**Addendum #1**  
**2020 Roadway Improvement Project**  
**“Cambridge Drive Neighborhood”**  
**Bid No. 20-15**  
**Town of East Hartford**

**February 28, 2020**

The following summarizes the revisions to the Bid Documents included in Addendum #1 for the 2020 Roadway Improvement Project (Bid No. 20-15).

HOLLISTER DRIVE AT NASSAU LANE

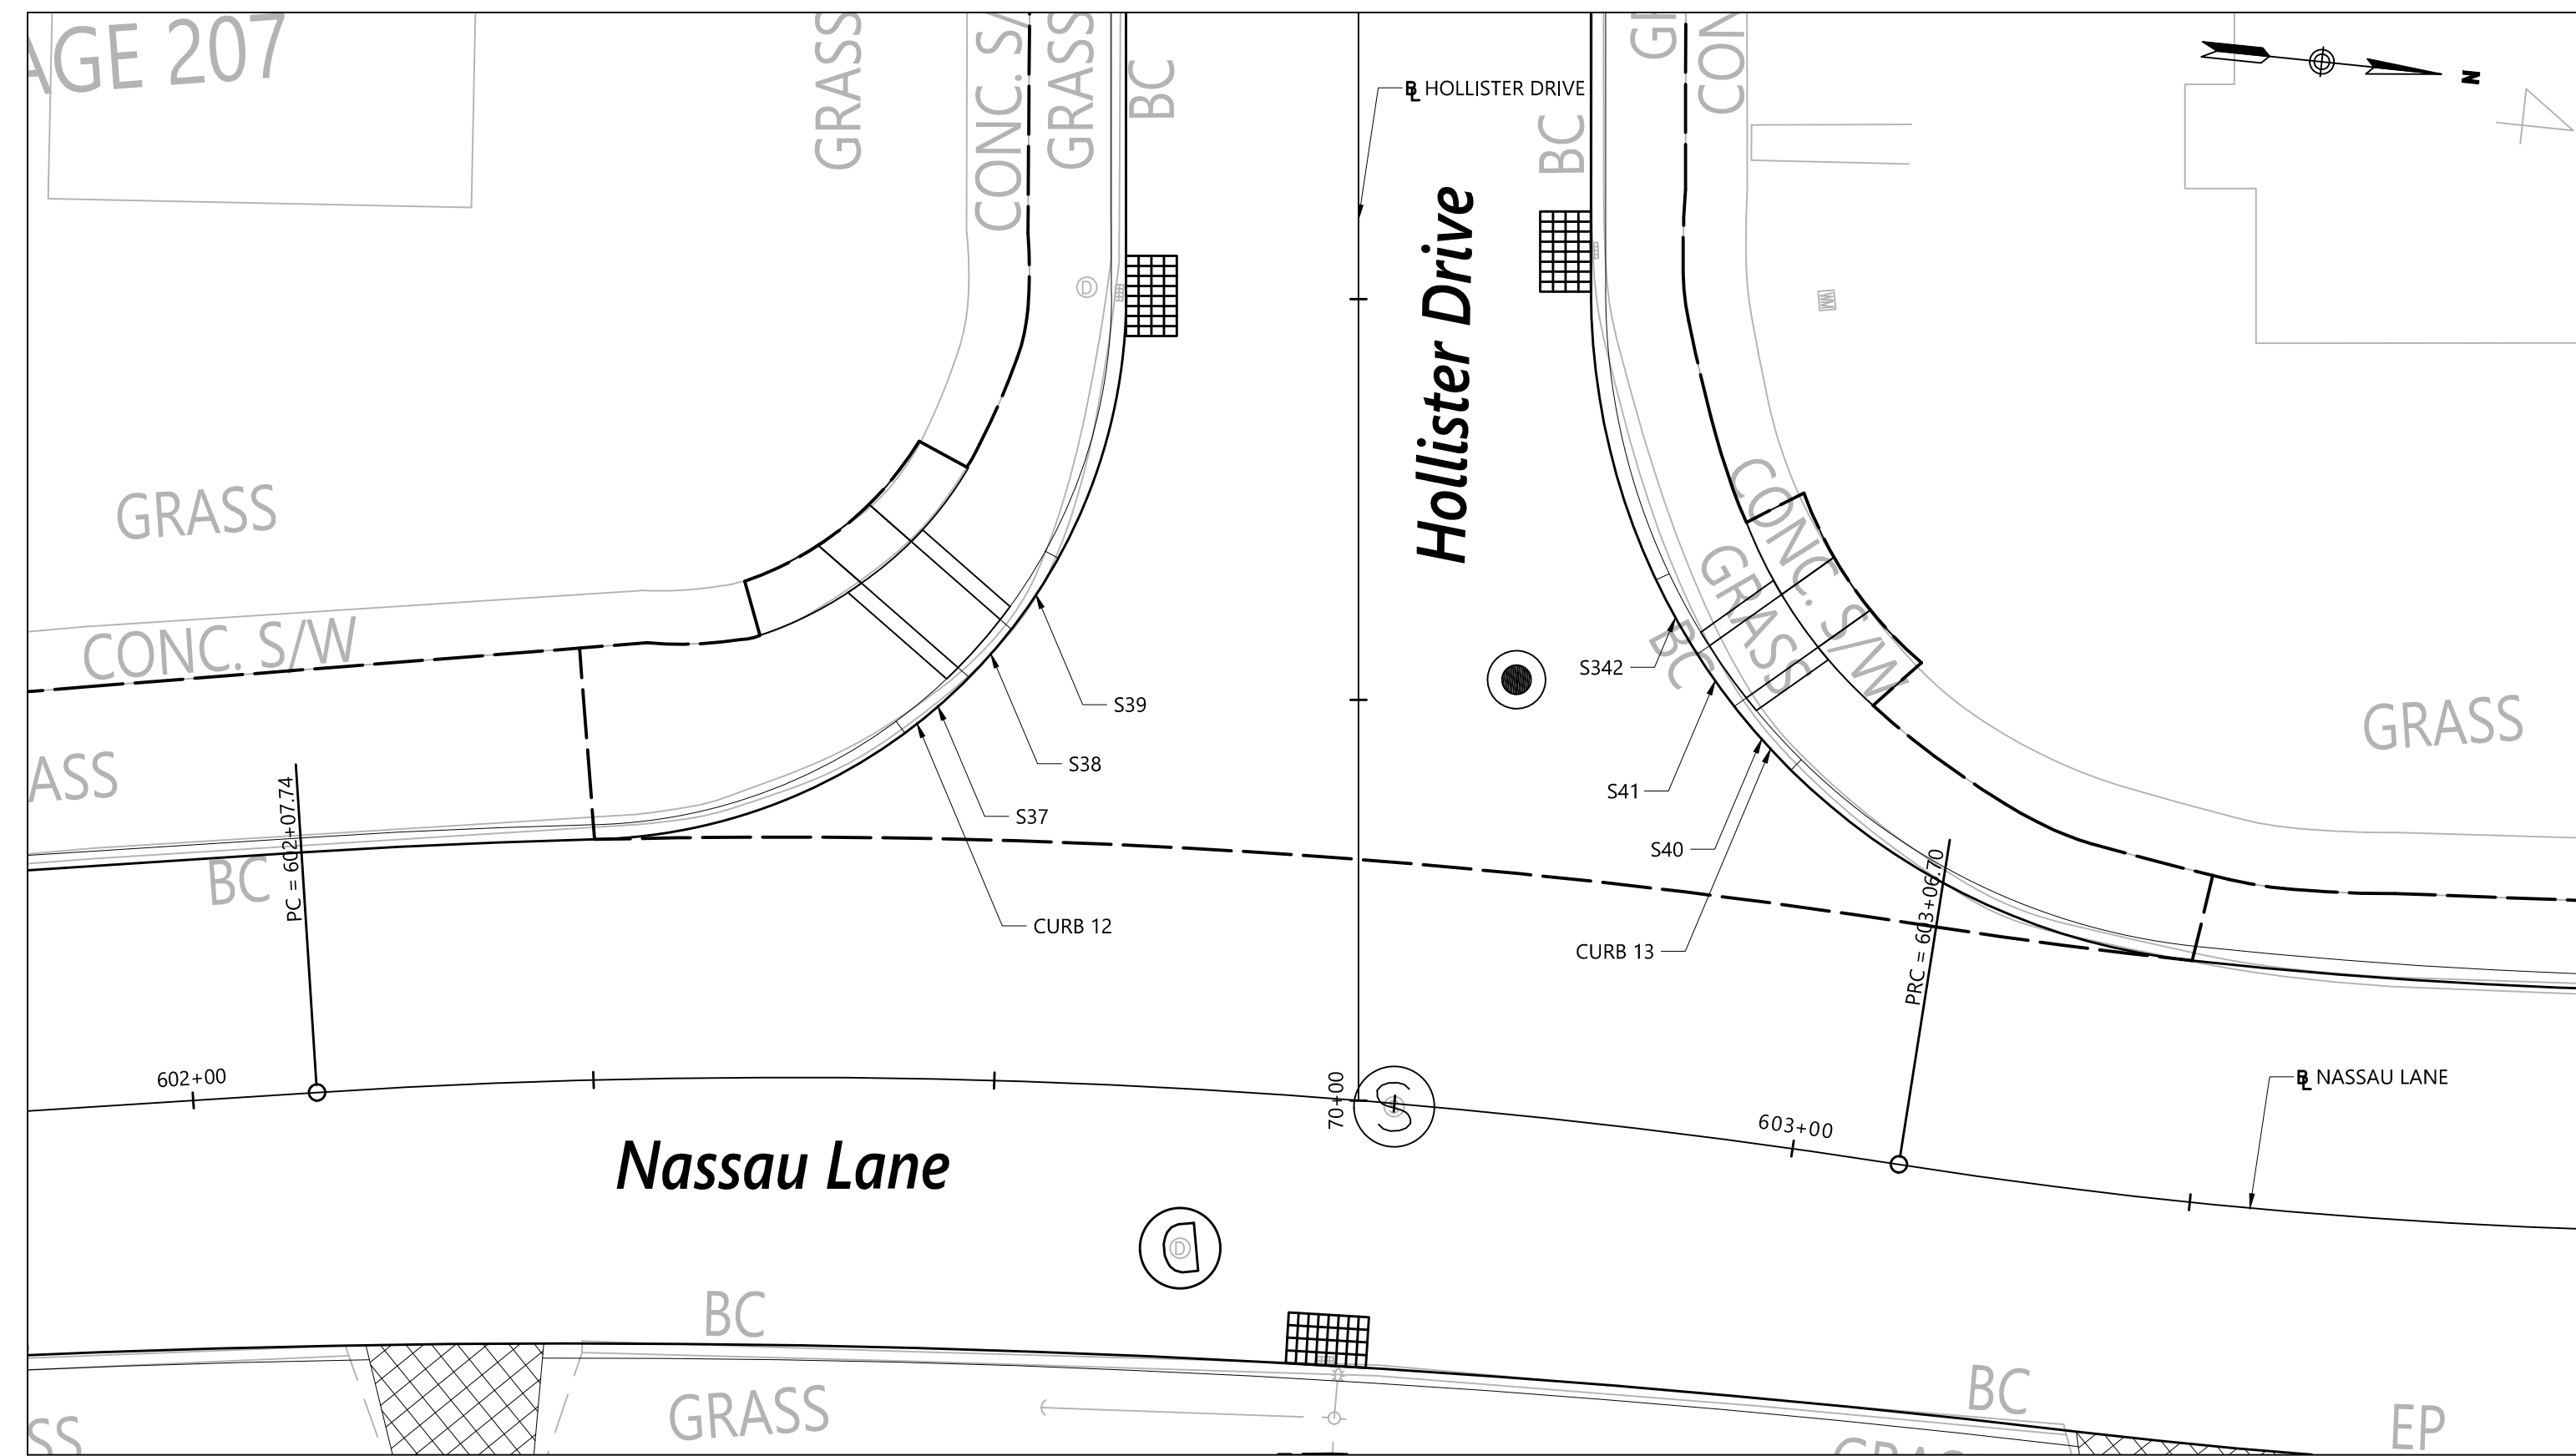
- Replace plan sheet 069 of 294 to reflect revisions to sidewalk ramp layout, curb layout, granite curb table, and calloffs.

REV.	DATE	DESCRIPTION	SHEET NO.
1	02/27/20	REVISED RAMP AND CURB LAYOUT, CURB TABLE, AND CALLOFFS	069

PROJECT NO.: 42413.00  
 DRAWING NO.: TIE-03  
 SHEET NO.: 070 OF 294

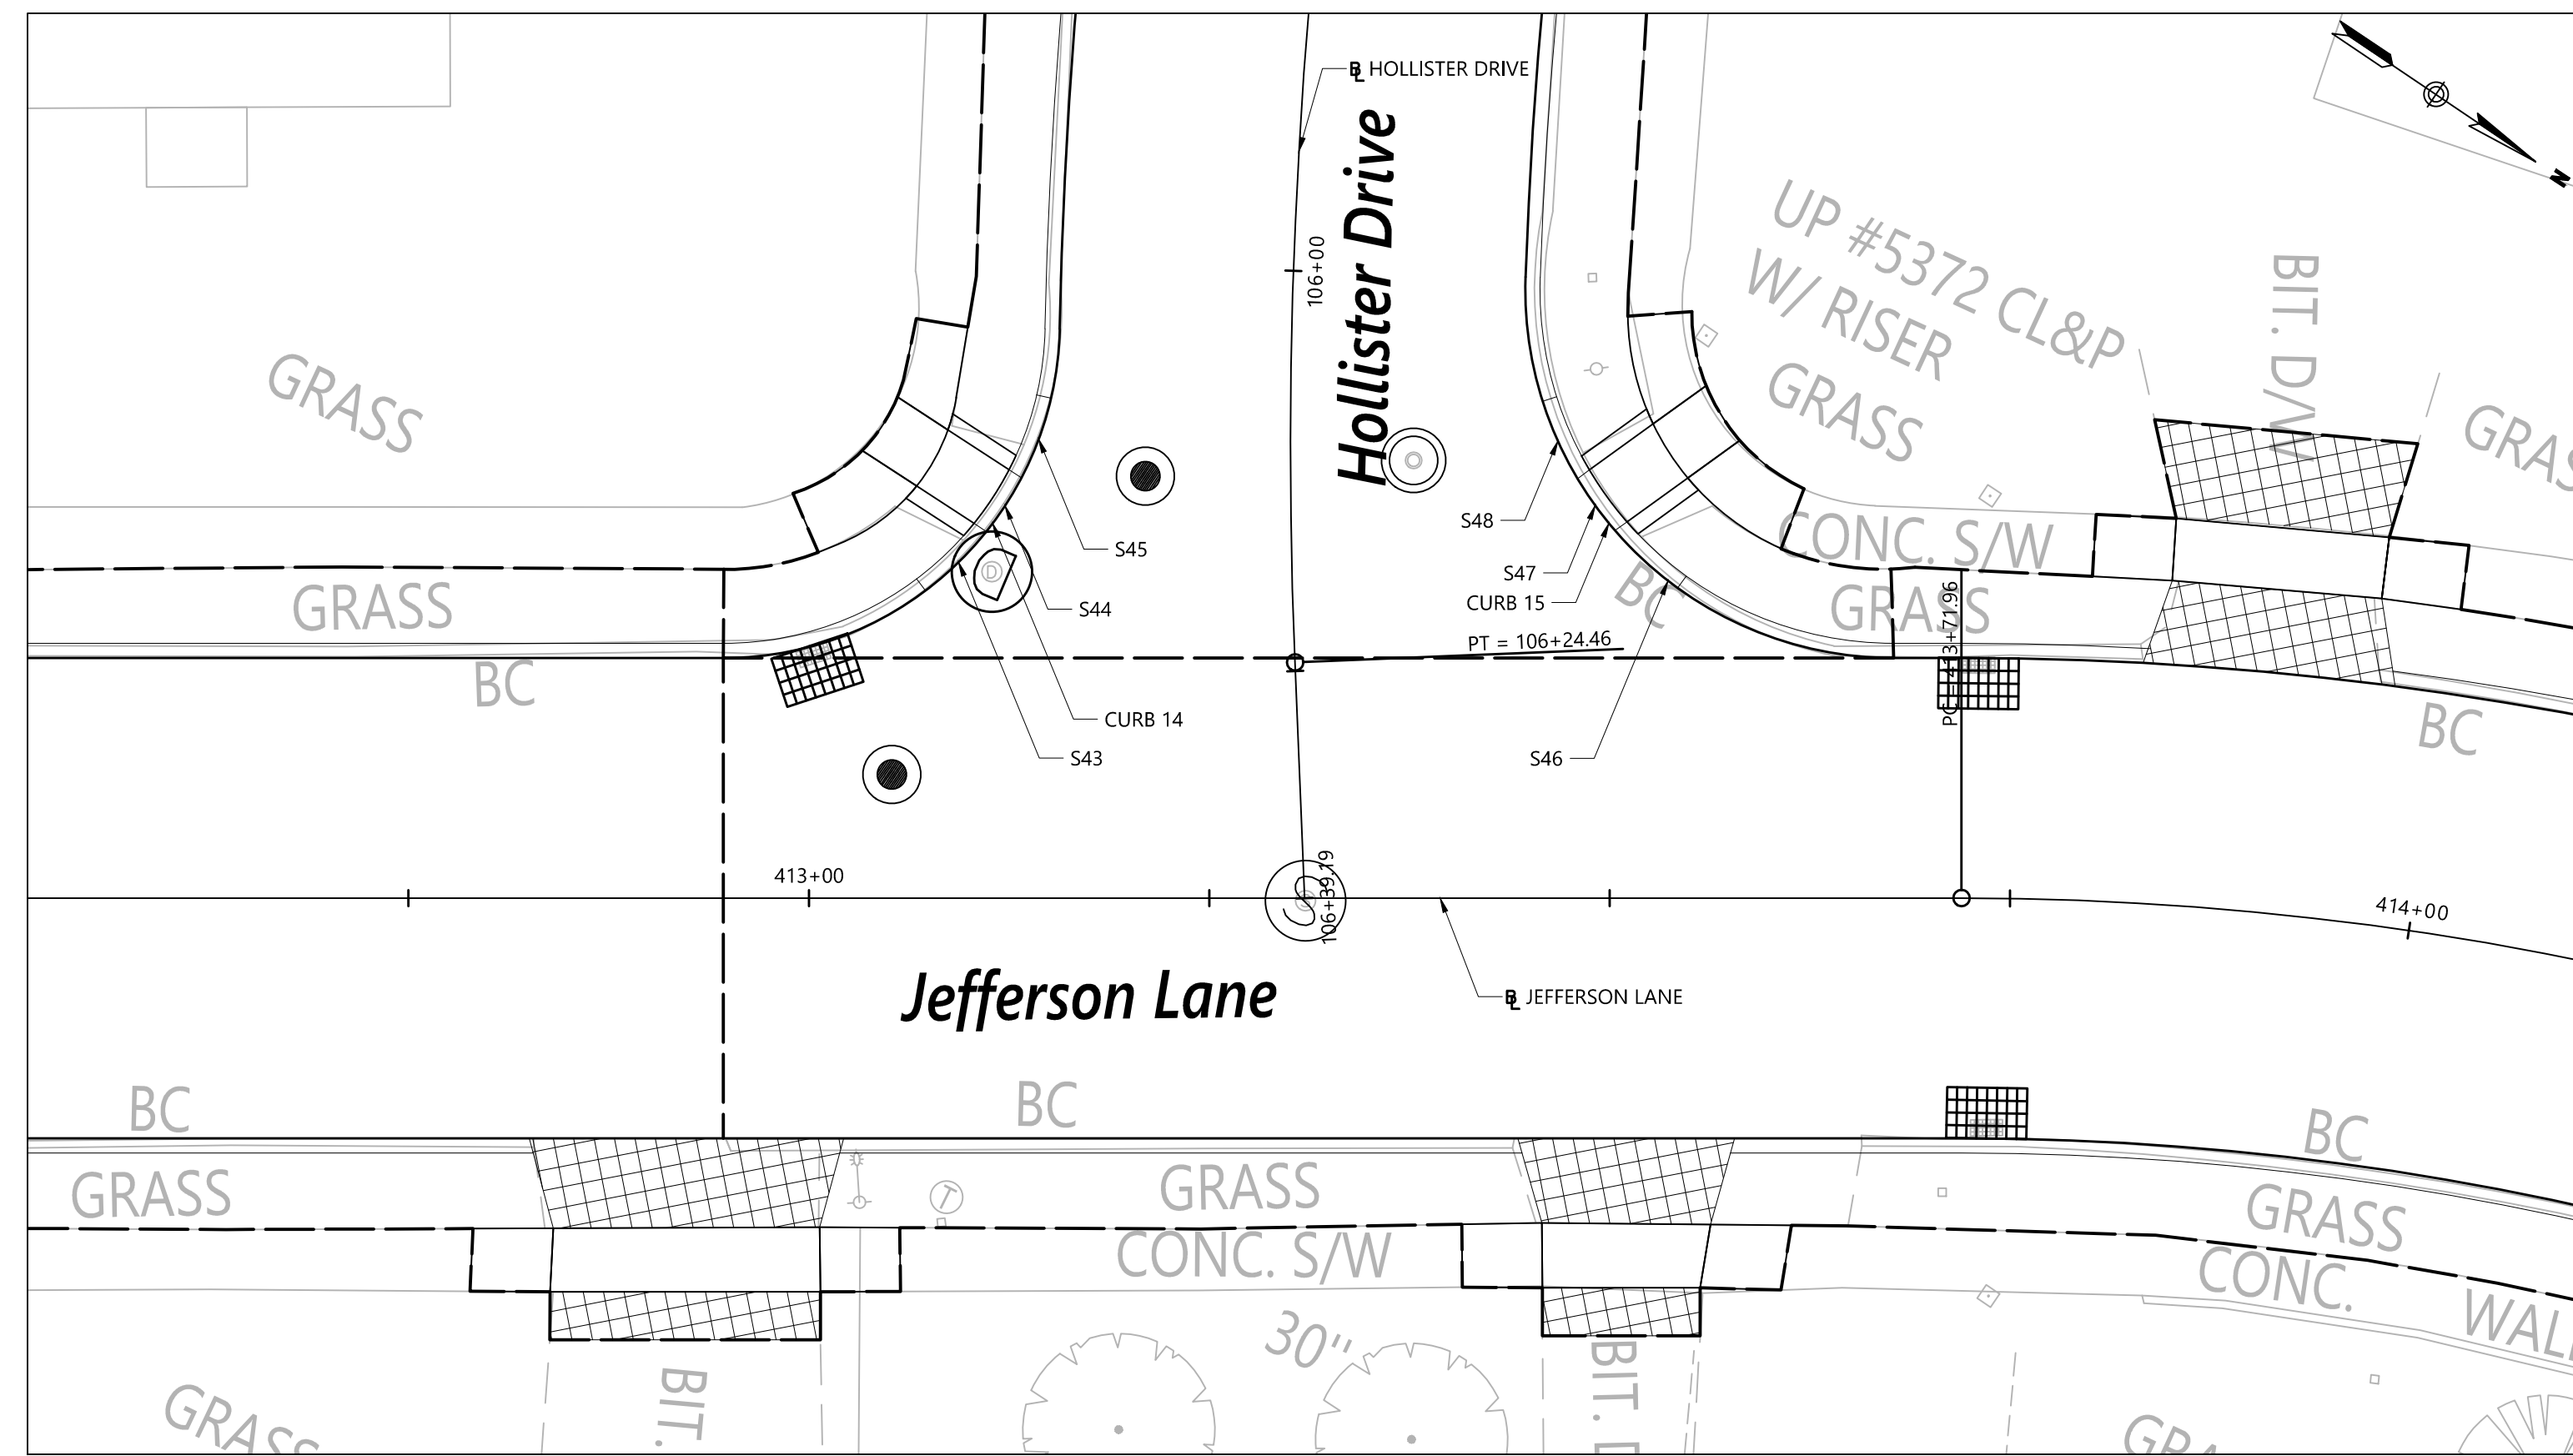
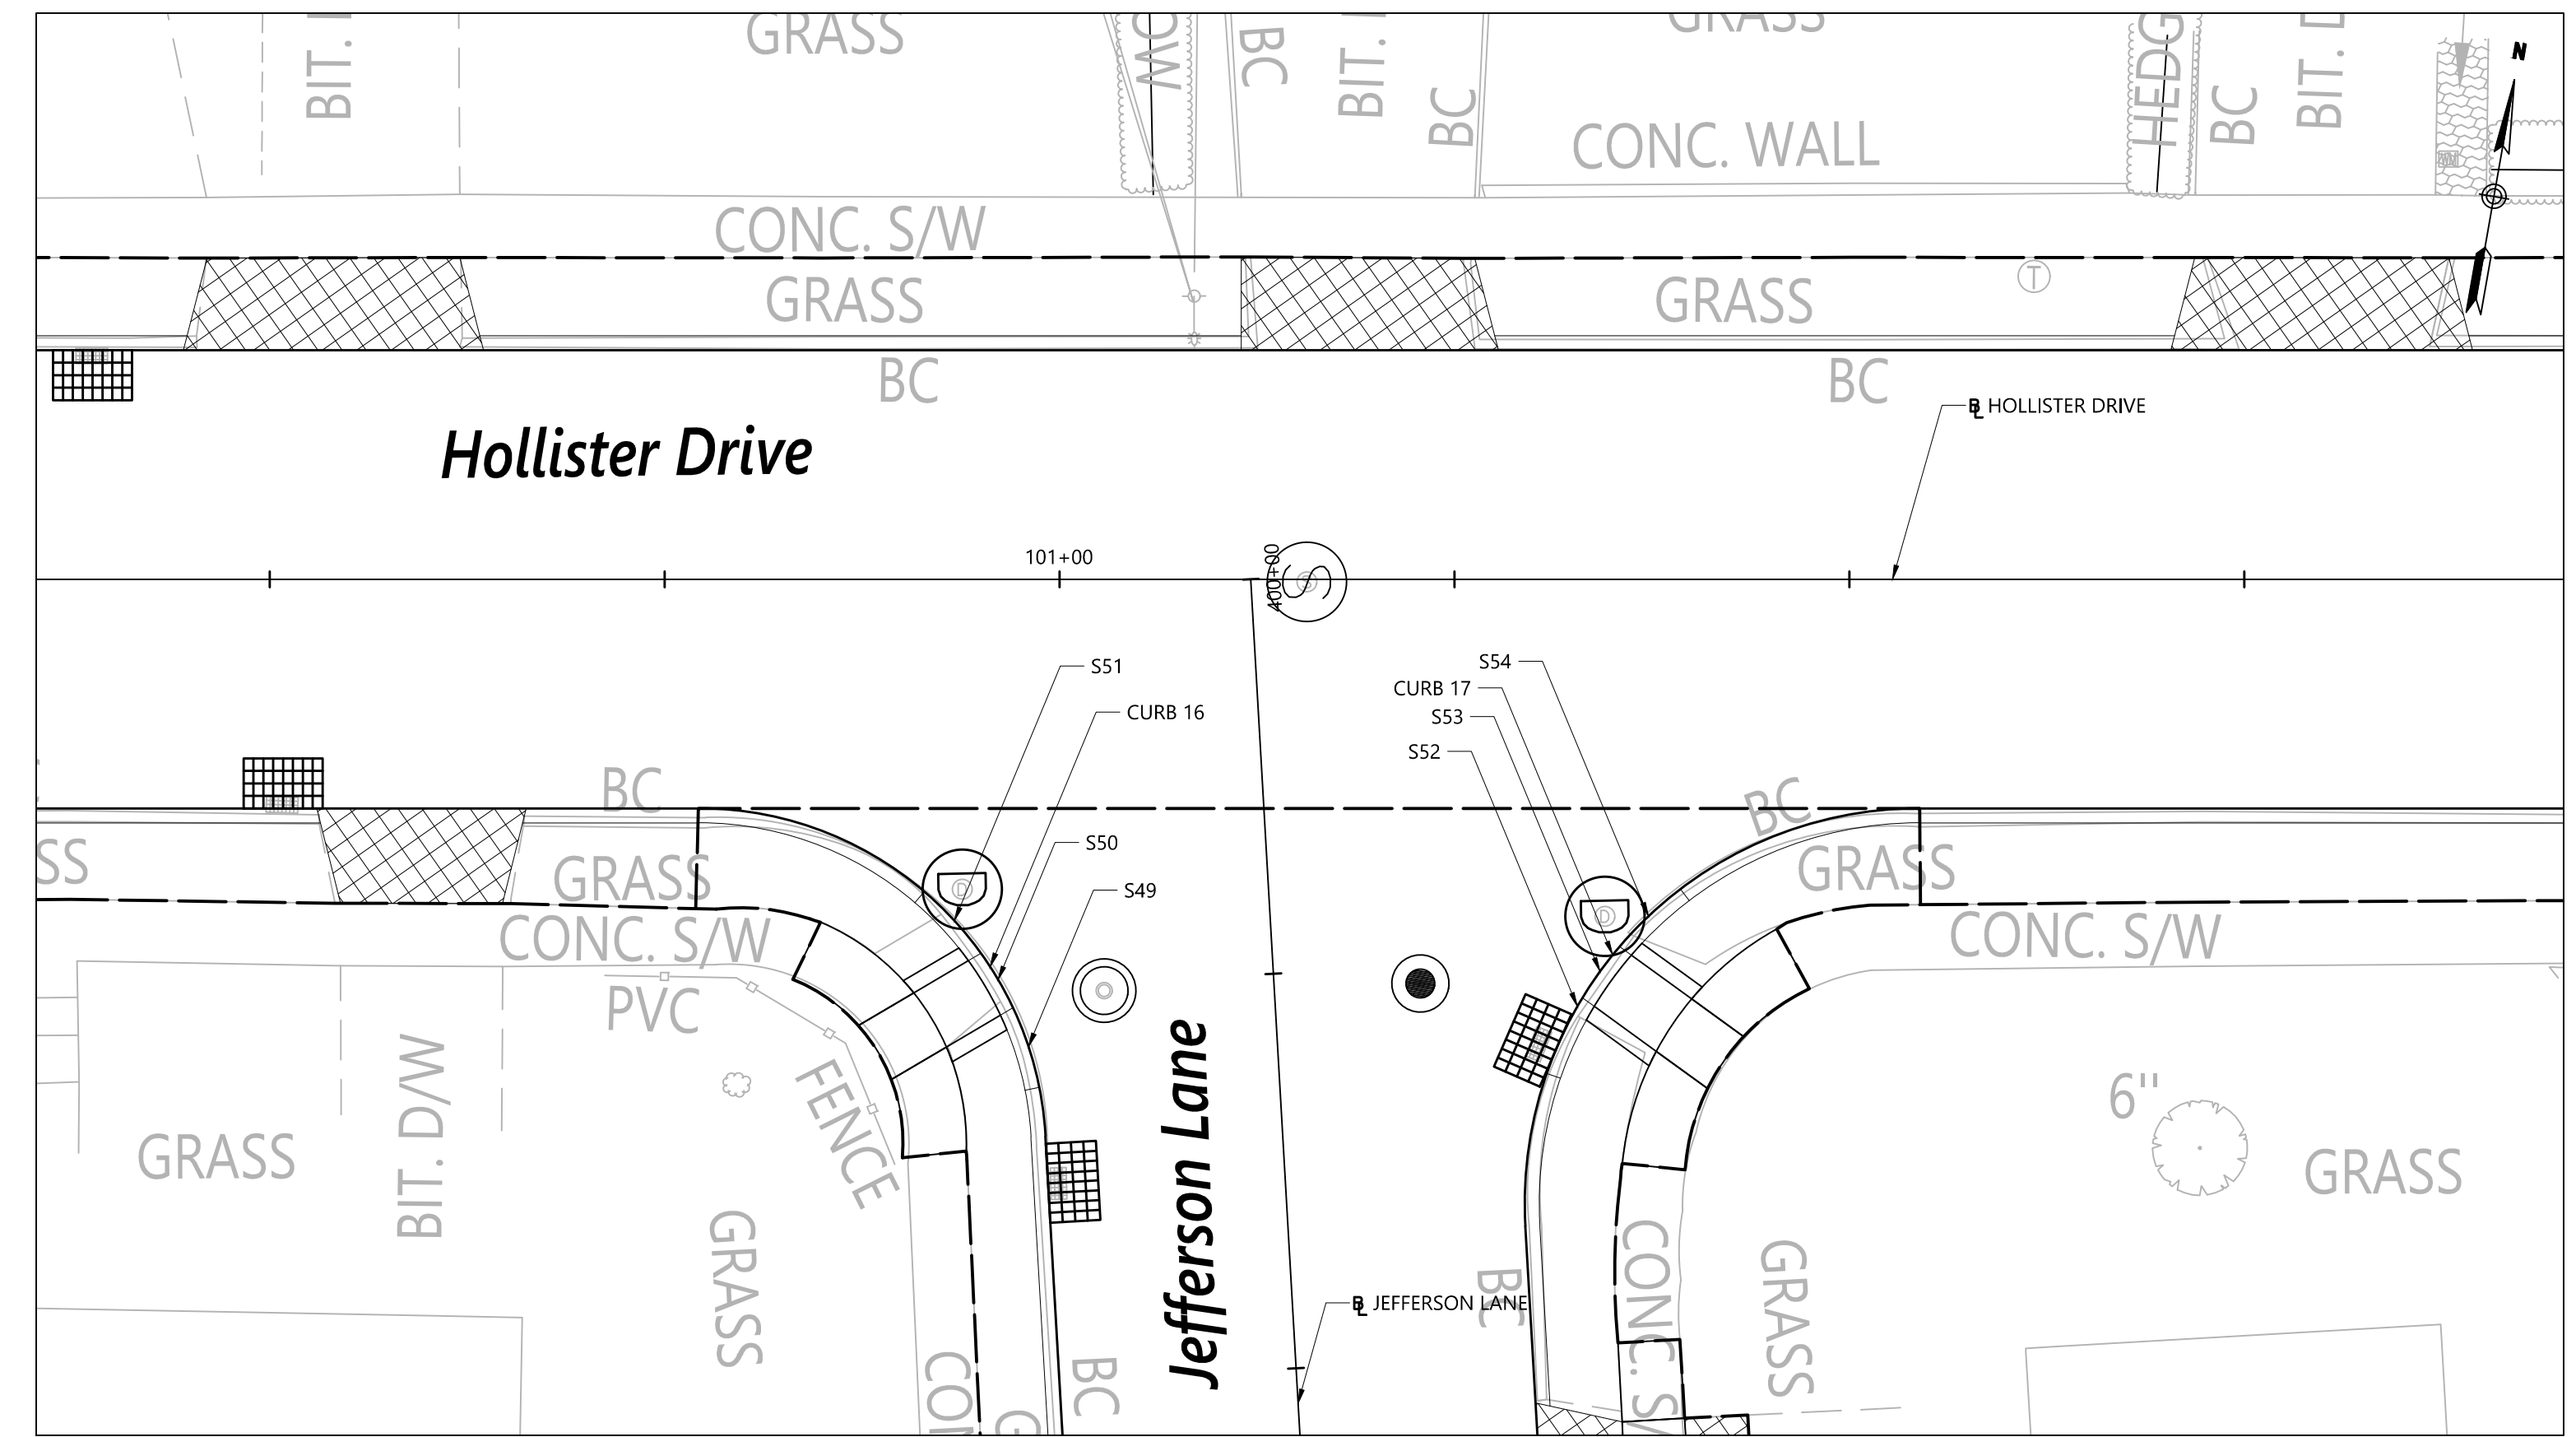
- Replace plan sheet 070 of 294 to reflect revisions to sidewalk ramp layout.

REV.	DATE	DESCRIPTION	REVISIONS	SHEET NO.
02/27/20	REVISED RAMP LAYOUT			070
